COLCHESTER, VT - TH 27  
 OVER INDIAN BROOK  
 ASSEMBLY PLAN

Vermont Agency of Transportation  
**RECEIVED**  
 CK'D BY R Klinefelter OK'D BY \_\_\_\_\_  
 August 7, 2015  
 RESUBMIT Yes Rejected \_\_\_\_\_  
 BY DATE 08/10/2015

SHEET NUMBER  
**1**

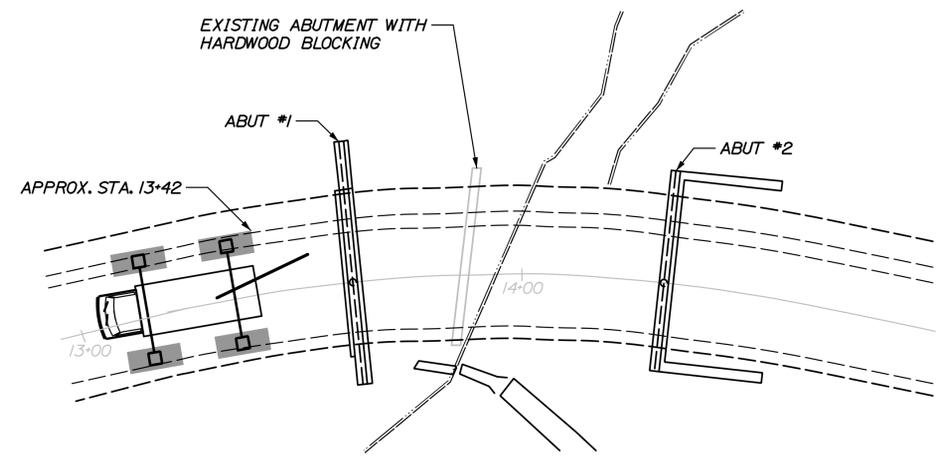
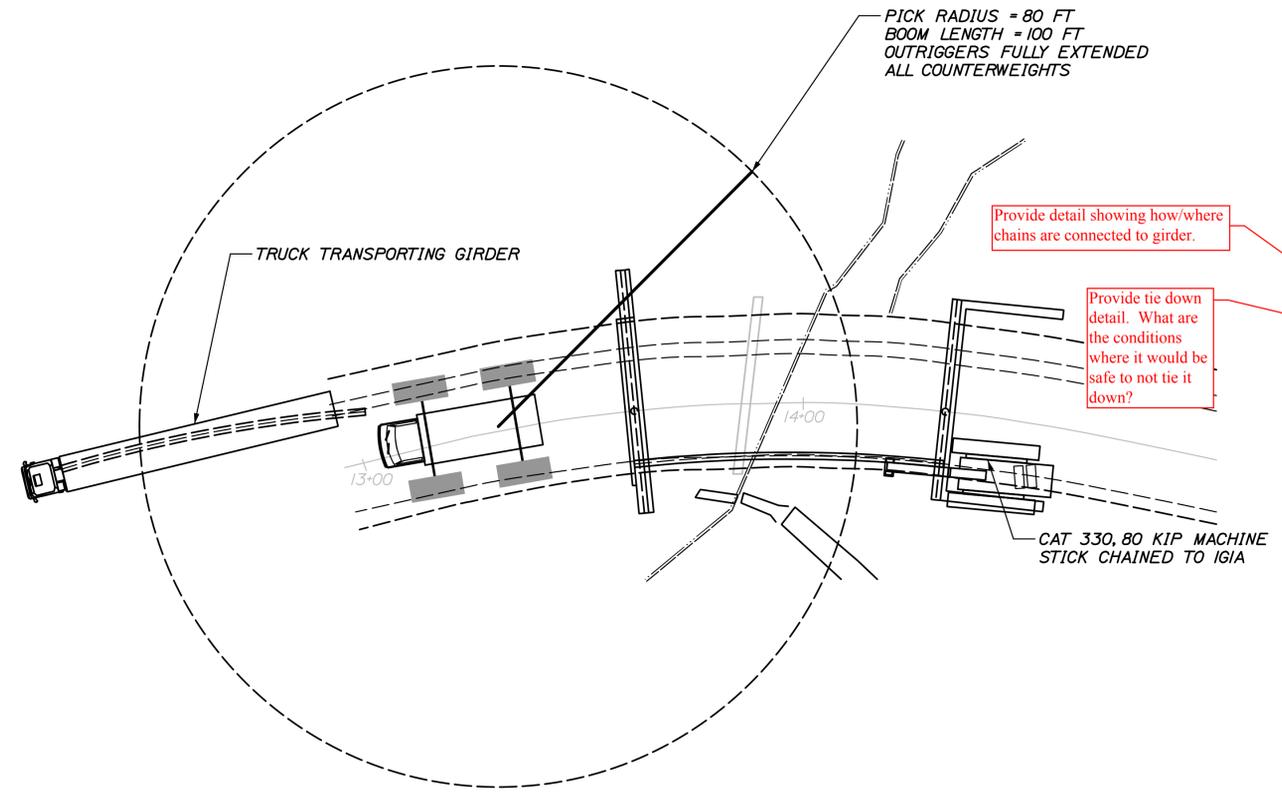
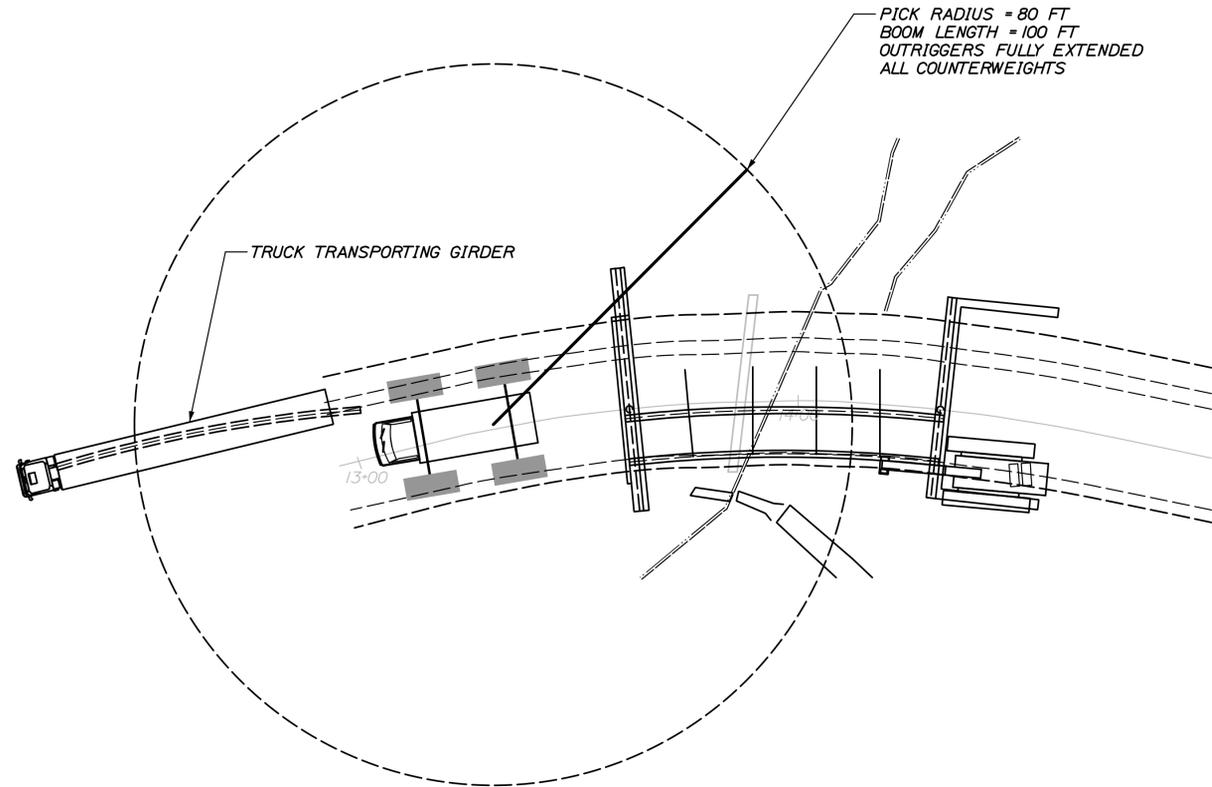
If temporary supports will be used on the new abutments in place of the bearings, provide details of supports and explain how supports will be removed to install bearings.

Crane chart has note stating that 80' max radius to be used for all picks. Is larger radius for diaphragms? Clarify

Provide blocking detail, specify where girders are to be supported

Provide detail showing how/where chains are connected to girder.

Provide tie down detail. What are the conditions where it would be safe to not tie it down?

SHEET NUMBER  
**2**

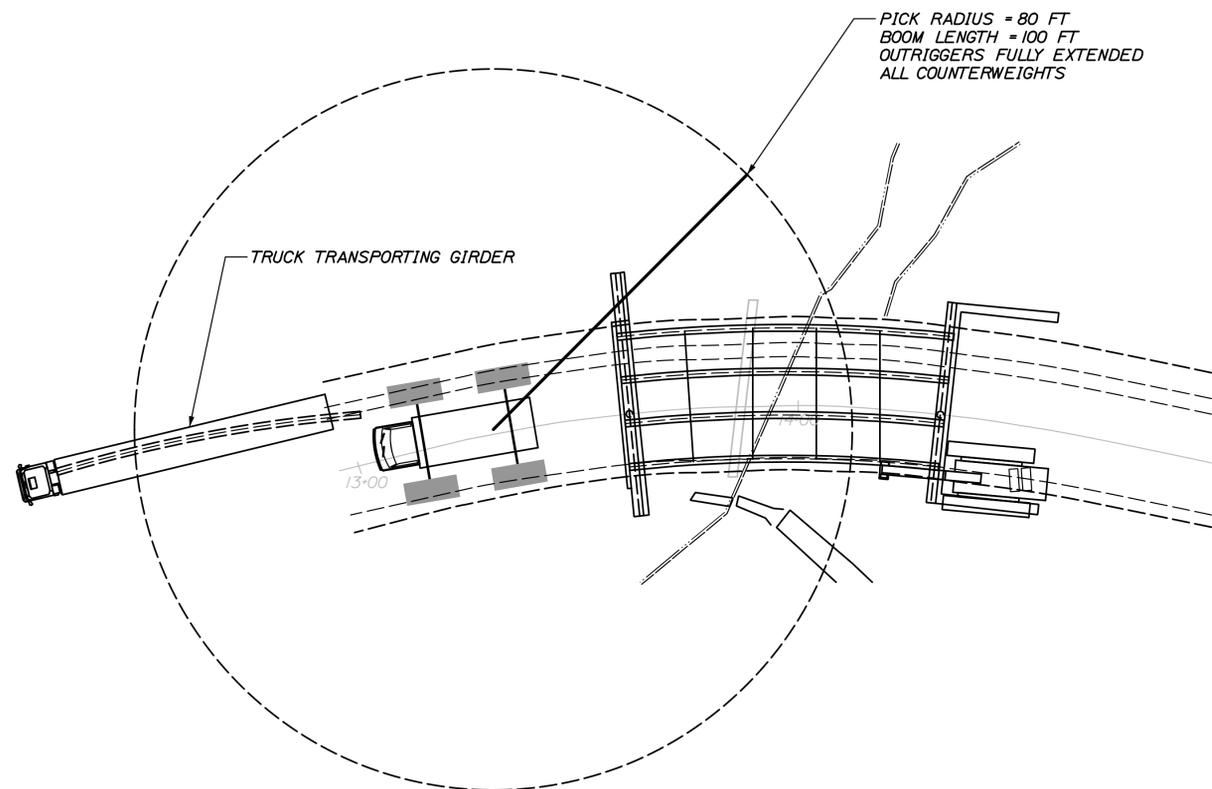
Define diaphragm bolting requirements for each stage.
